FL659A-C

NHTSA # 14V-075 (Non-Schools Buses)

NHTSA # 14V-074 (School Buses)

### Subject: TBB Minotour Rear Floor Reinforcement

Figure 1

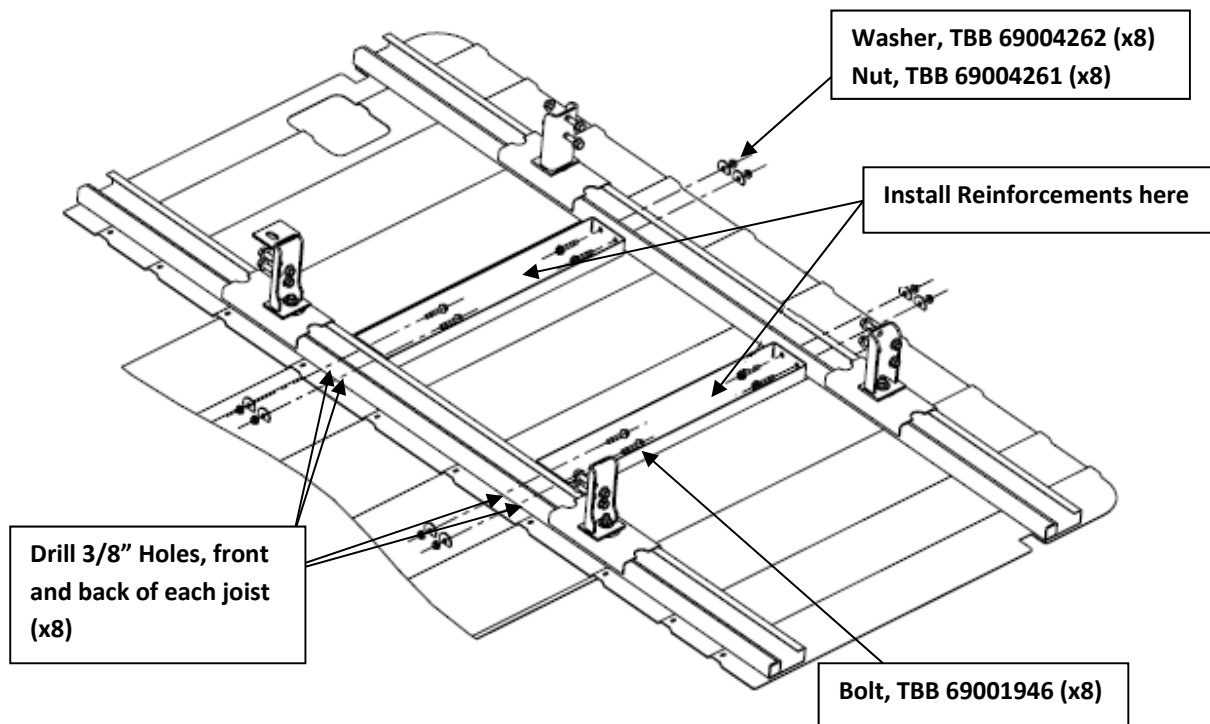
1. Chock wheels, shift into Neutral or Park. Set parking brake.
2. Remove any fasteners located at the area where reinforcements will be installed, such as seat bolts.
3. Position the reinforcement with the bend side down in the location shown in the installation diagram below that matches the bus. (See **Figure 1** below and diagrams at the end of these Work Instructions.)
4. Mark the location of each hole using a white grease pencil. Move the reinforcement to next the location and repeat.
5. Drill eight (8) 3/8" holes in the front side of the last joist and the back side of the second to last joist so that the reinforcements can be installed in the proper location. **Note: Each set of two holes must be drilled all the way through each joist. Figure 1**

6. Mount reinforcement TBB 185459 or TBB 186111 to the floor joists using bolt TBB 69001946, washer TBB 69004262, and nut TBB 69004261.
7. If any seat fasteners were located in this area, re-drill fastener holes from inside the bus through the reinforcement.
8. Reinstall seat fasteners through the reinforcement. Torque to 14 ft.-lbs.
9. Apply undercoating.
10. Unchock the wheels; place back into service.
